LAND DEPARTMENT.

BUILDING COMPLETION REPORT.

I beg to report the building work on plot No. 109 Sheet 9.1Sadar Bazar Quarter owned by Mr. Rhanna Deoji Samji

AMENDED
PLAN FOR PROPOSED SHED ON 2ND FLOOR OF

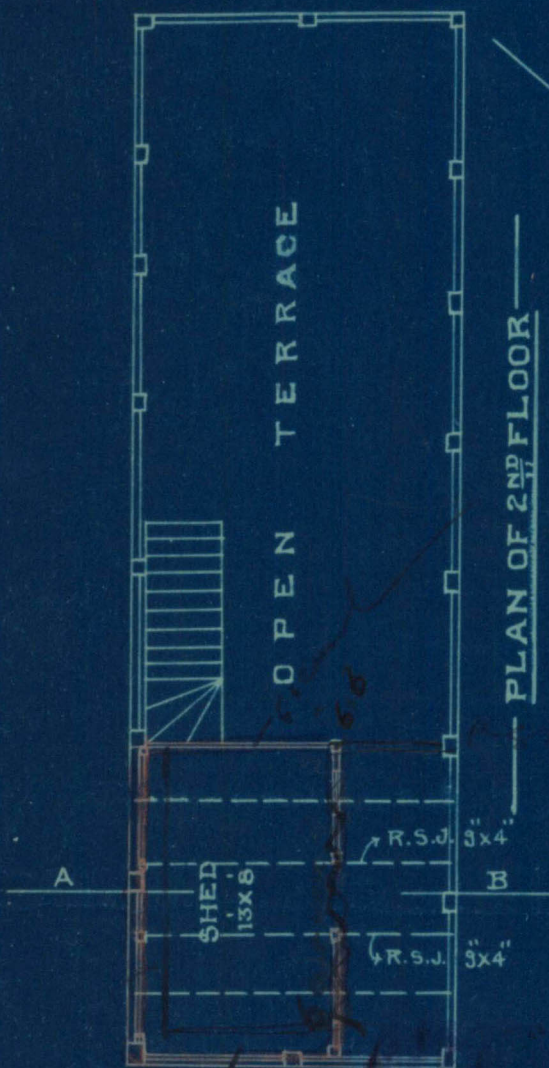
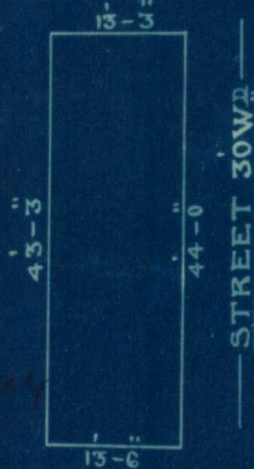
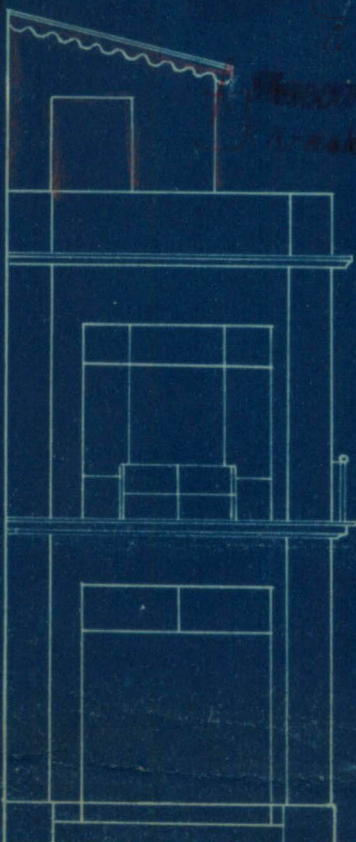
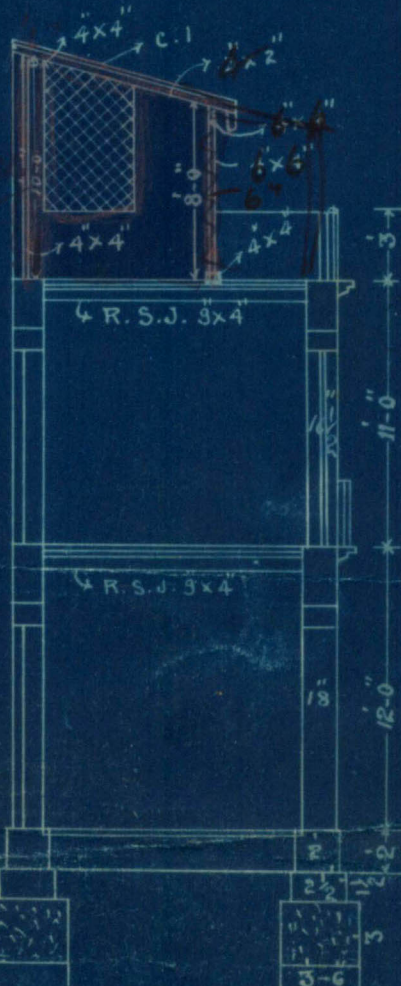
With reference to ^{his}_{their} application dated 10-10-27 with aplan for the proposed ^{Building}_{additions} on plot No. 109 Survey Sheet No. G-1

until the following requirements are complied with the plans cannot be passed.

- (1) Shed cannot be allowed, if the owner wants one room, he should build it according
- (2) to plan passed.
- (3) External walls should be pucca.

The owner has built the ground and one upper floor. In the first floor, he has ~~omitted to~~ provided only one w.c. instead of two as per approved plan. Submitted for order
